## **BROAD STREET RESTORATION SUBDIVISION**

Engineering Comments:     **FINAL PLAT COMMENTS** (should be addressed prior to submitting the FINAL PLAT for review and/or signature by the City Engineer):

APPLICATION NUMBER 2 DATE December 6, 2018

# DETAIL SITE PLAN

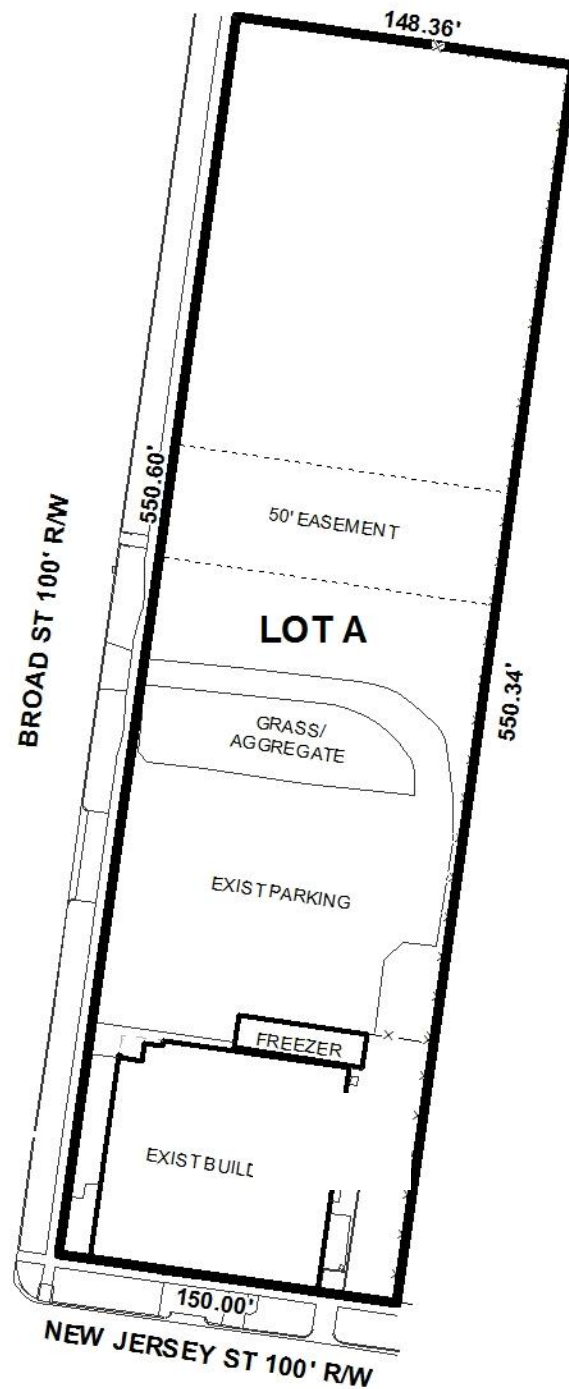
The site has frontage on South Broad Street and New Jersey Street. South Broad Street is a component of the Major Street Plan with a planned and current 100' right-of-way; therefore, no dedication would be required along South Broad Street. New Jersey Street is a minor street with a current 100' right-of-way; therefore, no dedication would be required along New Jersey Street. The current right-of-way widths of both streets should be retained on the Final Plat. A 25' corner radius should be dedicated at the intersection of South Broad Street and New Jersey Street. The plat should be revised to label the lot size in both square feet and acres after required dedication, or a table should be furnished on the Final Plat providing the same information. The site is not within a historic district; therefore, the standard 25' minimum building setback line would apply. The plat should be revised to depict the 25' minimum building setback line along both street frontages.

The plat indicates a 50' drainage and utility easement in the area of the vacated portion of Delaware Street. Therefore, a note should be required on the Final Plat stating that no structure may be constructed or placed within this easement.

- 1) retention of the current right-of-way widths of South Broad Street and New Jersey Street on the Final Plat;
- 2) dedication sufficient to provide a 25' corner radius at the intersection of South Broad Street and New Jersey Street;

- 3) revision of the plat to label the lot size in both square feet and acres after any required dedication, or the furnishing of a table on the Final Plat providing the same information;

- 4) revision of the plat to illustrate the 25' minimum building setback line along both street frontages;
- 5) placement of a note on the Final Plat stating that no structure may be constructed or placed within the drainage and utility easement;
